INFORMATION LETTER

212-21-73

SUBJECT: TAIL ROTOR BLADES 212-010-750-ALL LEAK CHECK.

Figure 1. Areas where cracks can be found.

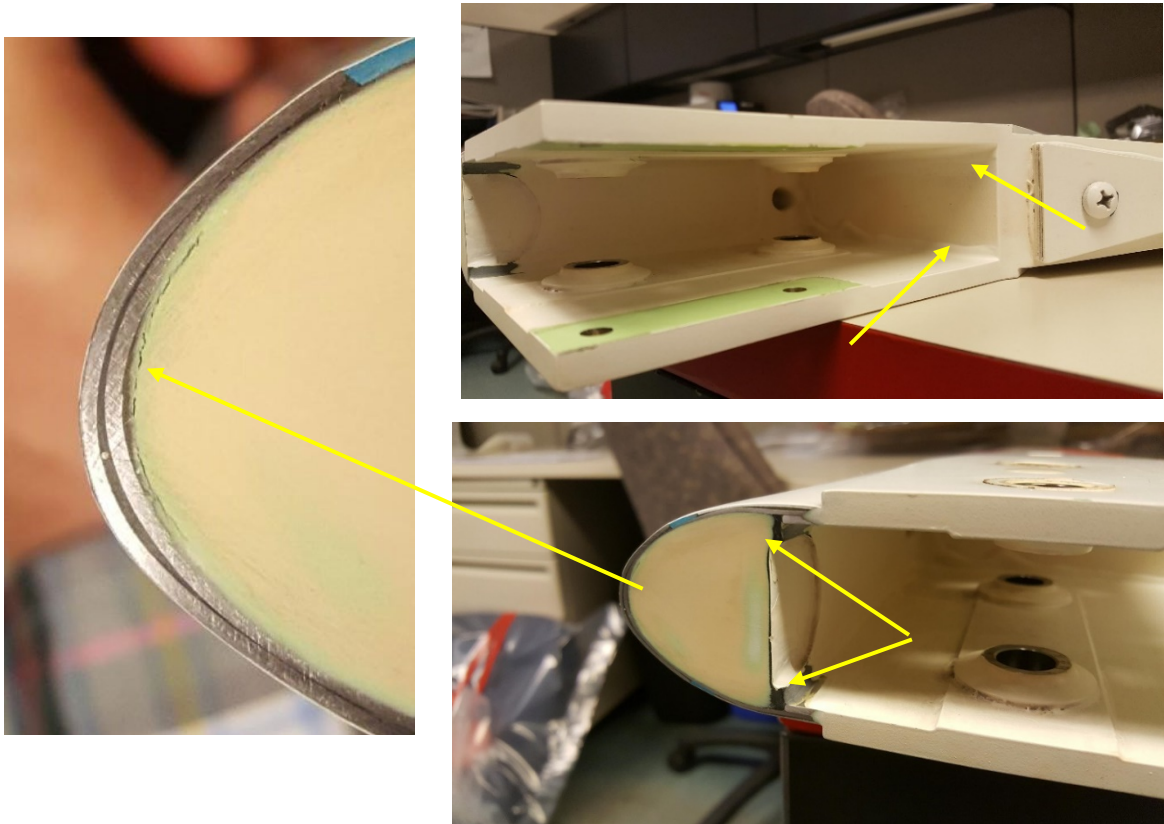
Bell has received reports of tail rotor blades failing the leak check required per the applicable Maintenance Manual (MM) when suspected cracks are found in the blade root end cuff area. In some cases, due to misinterpretation of the results, blades rejected due to indications of air bubbles were in fact serviceable. Figure 1 below shows some areas where cracks can be found. The cracks found in the root end cuff area are usually limited to the adhesive squeeze-out produced during manufacturing and are not necessarily an indication of a bonded joint failure.

The crack repair procedure found in the applicable MM and Component Repair and Overhaul Manual (CR&O), has also been changed. The adhesives (C-363) and (C-313) listed in the MM and the CR&O to repair cracks in the root end area are replaced by sealant (C-308). The flexibility of sealant (C-308) will allow the fine cracks to remain sealed and prevent further cracking with time in service.

This Information Letter also reminds operators of the requirement to perform a leak check per the MM if signs of delamination or cracks are found on the blade or if excessive tail rotor vibrations are reported with no apparent cause. It is also important the blade be slowly submerged in water tank and gently rotated back and forth to avoid creation of bubbles. Moving and rotating the blade rapidly in water could cause bubbles that can easily be misinterpreted as an air leak.

“Check for air leaks indicated by fine air bubbles originating from a single point at a rate exceeding one every five seconds. Occasional air bubbles is not a rejection criteria. If any confusion exists, or a clarification is desired, contact Product Support Engineering.”
